BOTLEY WEST SOLAR FARM
OXFORDSHIRE HOST AUTHORITIES
RESPONSES FOR
DEADLINE 6 | MONDAY 20 OCTOBER 2025

Botley West Solar Farm (EN01014)

RESPONSES FOR DEADLINE 6

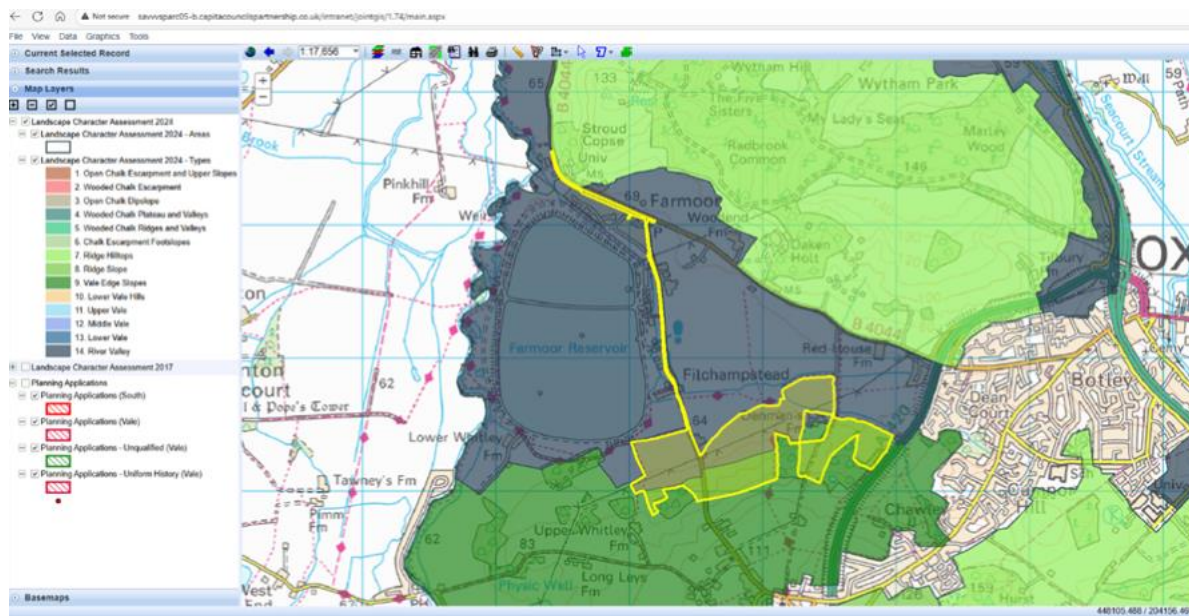
For example, the referencing of VoWH Landscape Character Areas (LCA) in the LVIA is not very clear. It is assumed that references are predominately based on the Landscape Character Type rather than the much more detailed LCA information. For example, the VOWH Landscape Character Assessment description of the 14A Farmoor Reservoir Valley LCA contains no reference to the River Thames or the Chiltern Way as neither are these located close to or within the 14A LCA, however, these are mentioned in paras 8.6.51 and 8.6.52 of the revised LVIA. The LCA Joint Landscape Character Assessment contains information about Key characteristics, Description, Valued qualities, Forces for change and Landscape strategies and guidelines but none of these are referenced in the [CR2-022] 6.3 version of the LVIA. However, it is noted that 8.6.53 does correctly reference the **South Oxfordshire and Vale of White Horse Renewable Energy Study Landscape Sensitivity Assessment**, which states that both the Northern Vale Edge Slopes LCT and River Valley LCT have ‘high’ landscape sensitivity to large scale solar energy development.

The associated ES - Figure 8.246 Local Landscape Character Areas and APP-143 6.5 ES – Appendix 8.1 Landscape Character in [APP-070] have not been updated to reflect the reference to the Vale of White Horse and South Oxfordshire District Council Joint Landscape Character Assessment 2024, and the Landscape Character Areas (LCA) present in the Southern Section of the site. If

these plans were updated, it would illustrate that the text within the LVIA is inaccurate with regard to where the LCA boundaries fall in association to the scheme. The 9G Northern Vale Edge Slopes LCA boundary is located approximately 130m to the south of the overhead lines and the 14A Farmoor Reservoir Valley LCA is located to the north of the 9G Northern Vale Edge Slopes LCA. Approximately half the southern solar area is in the 14A Farmoor Reservoir Valley LCA, including the locations for the site for the NG substation.
